# NEW ShyZip GS40 Spring

## New Spring Design

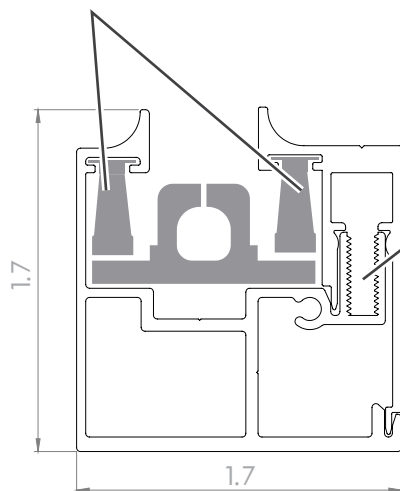
An exciting new design for ShyZip track will make screen operation run more smoothly. The new ShyZip GS40 Spring has been released and is currently being implemented on all screen shyzip orders. Detailed installation instructions will be shipped with all ShyZip orders.

This exclusive spring component has been created to replace the bumpers. The spring creates a more smoothly tensioned fabric and will have a longer life than the bumpers.

More space has been constructed into the new design to allow screws to grab more profile than before. This virtually doubles the closing force of the removable profile.
